Mack - North Phase (49-DR-2022#2)  
**Summary of Updates from Prior Submittal**

# MACK INNOVATION PARK

PHASE 1 - North

SEC of Loop 101 and Pima Road  
Development Review Application  
Application 49-DR-2022#2

DR39-B

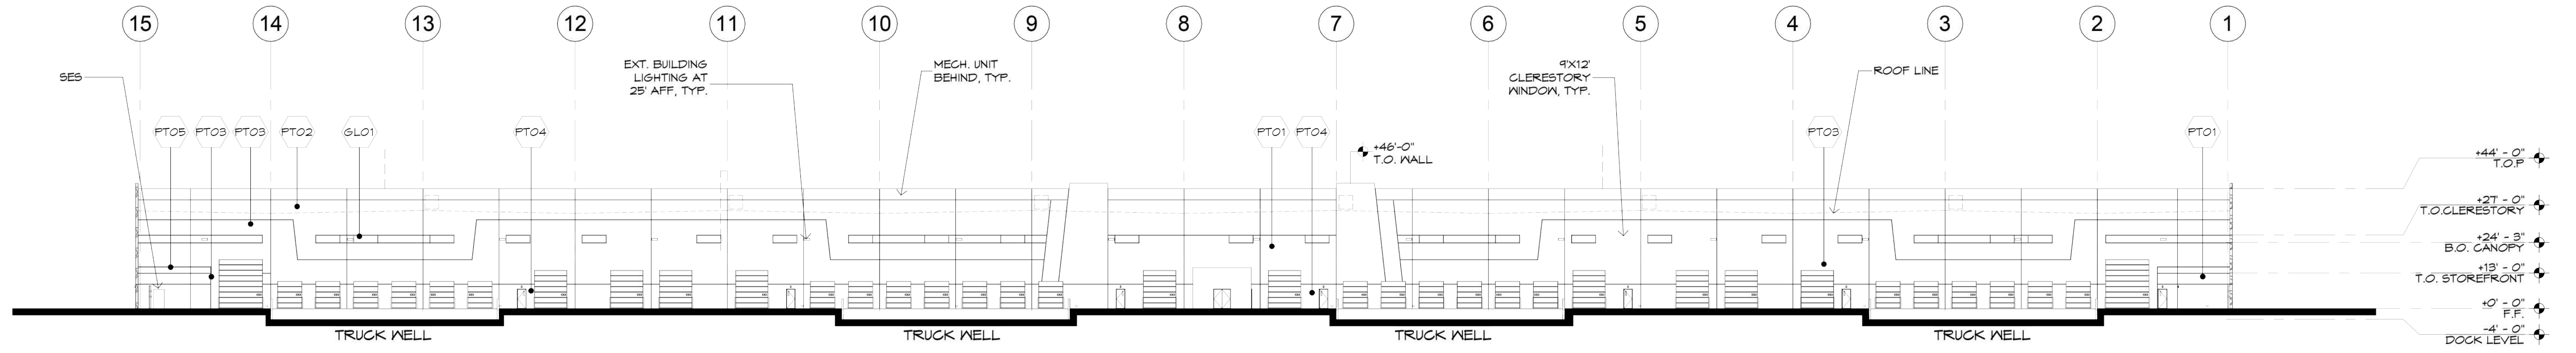
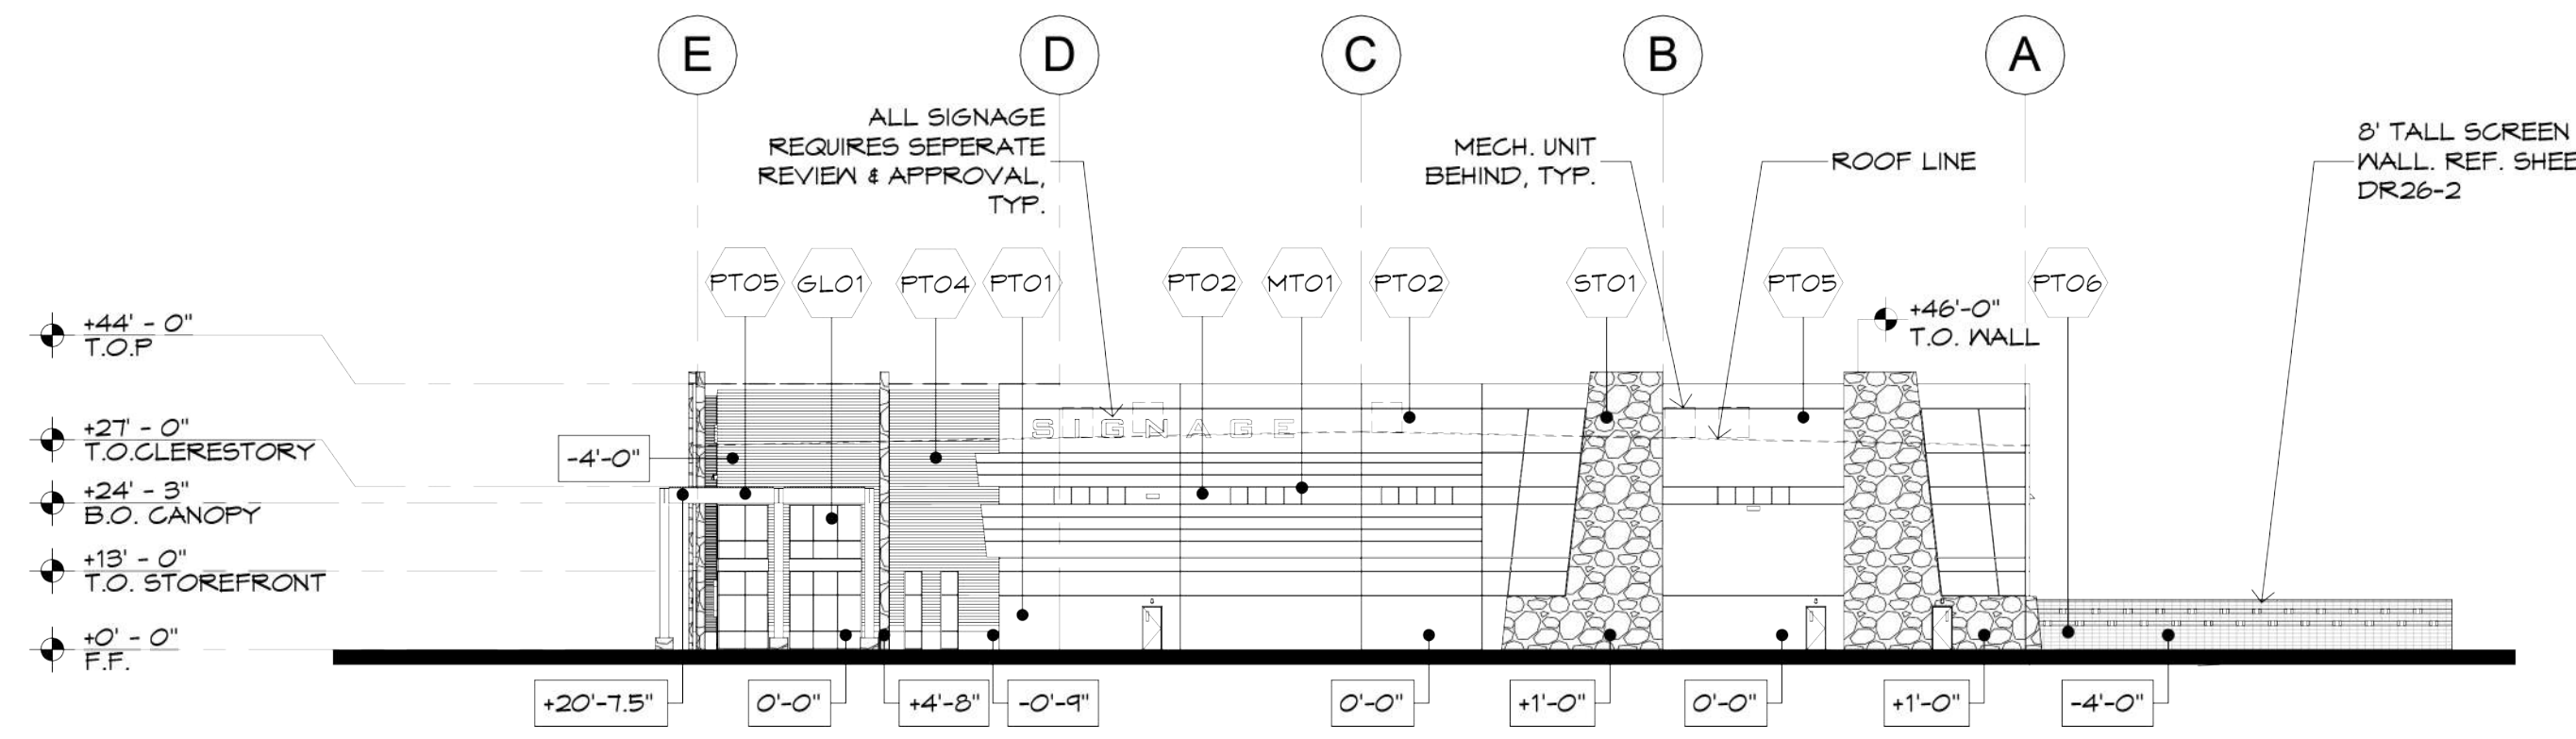
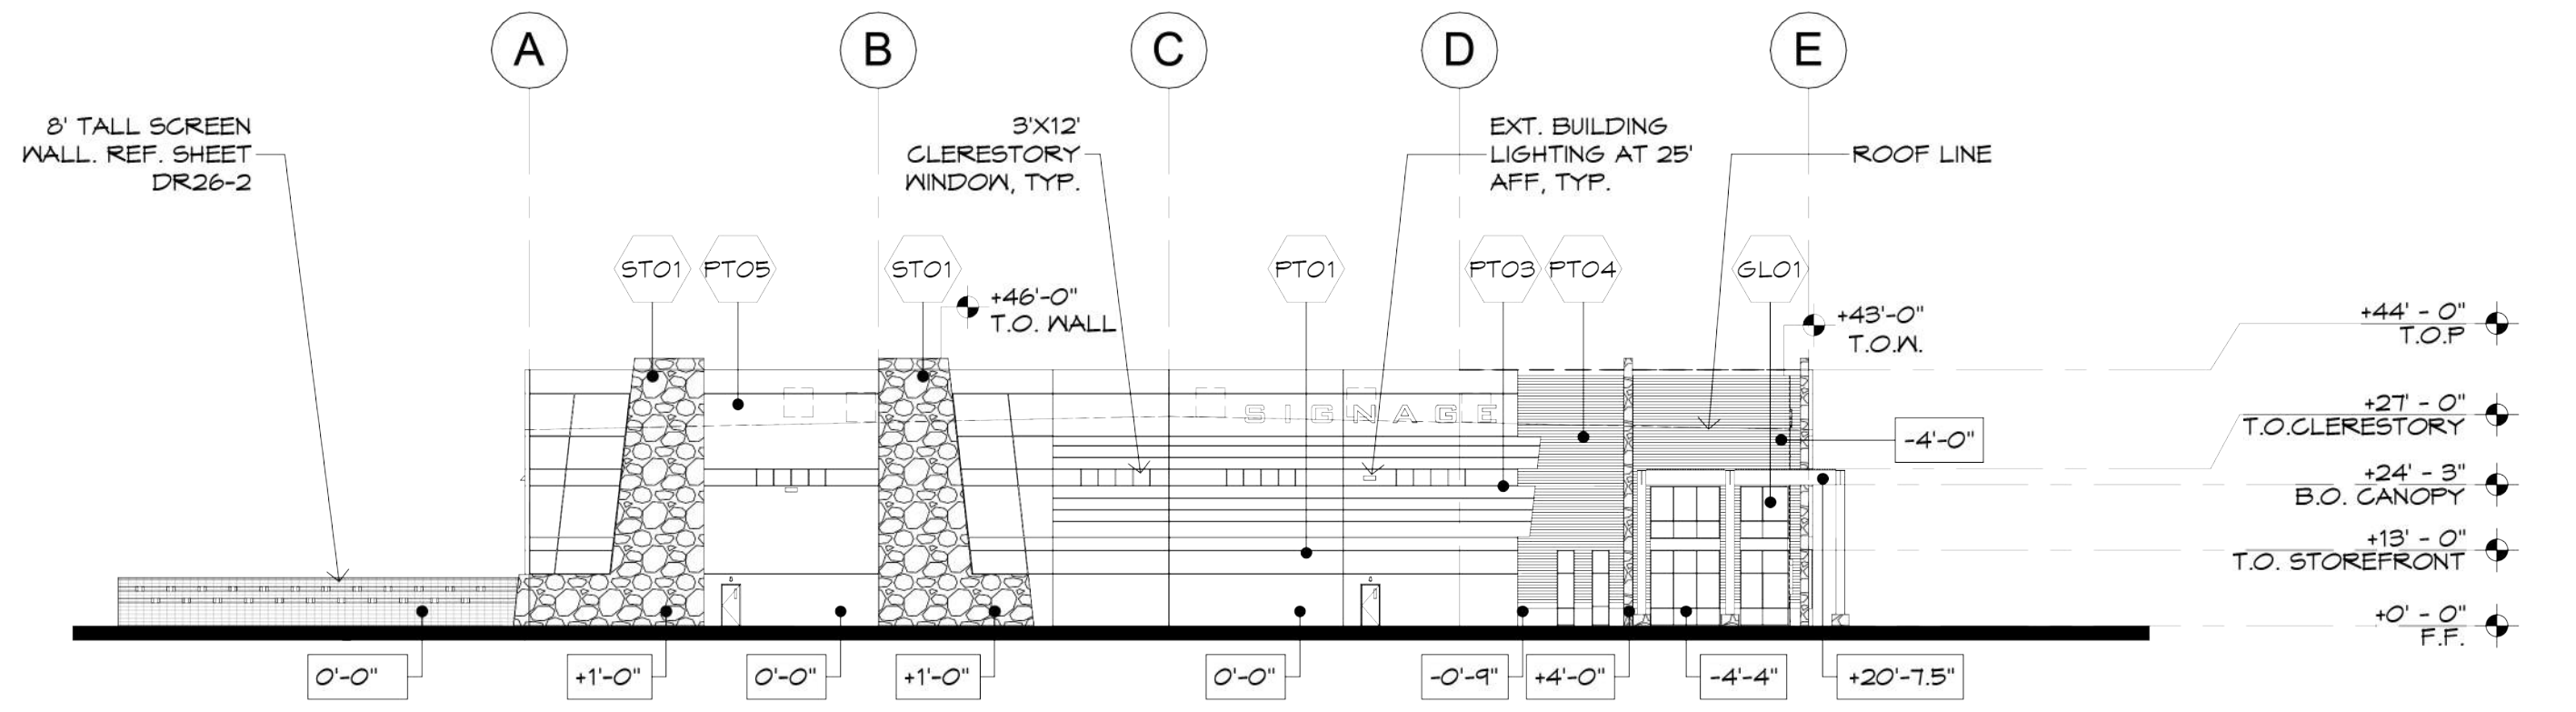
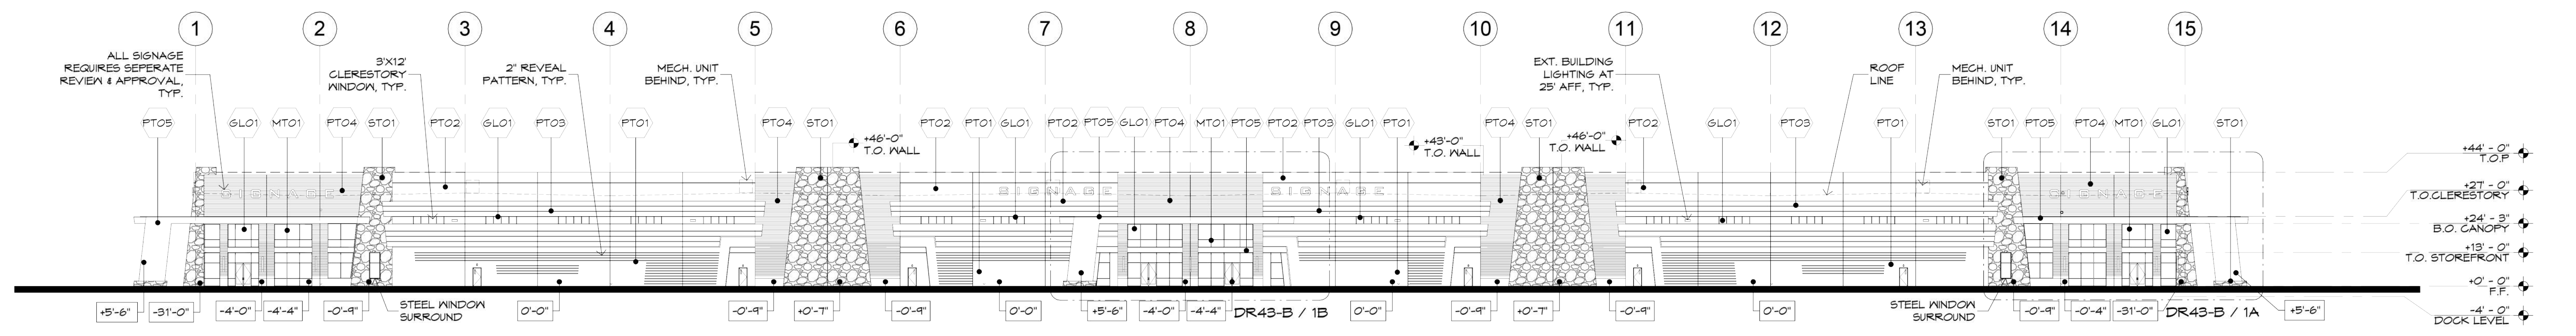
DR39 Revised B&W and Color Elevations

- Updated to show revised building exterior colors and loading dock elevations with added architectural details
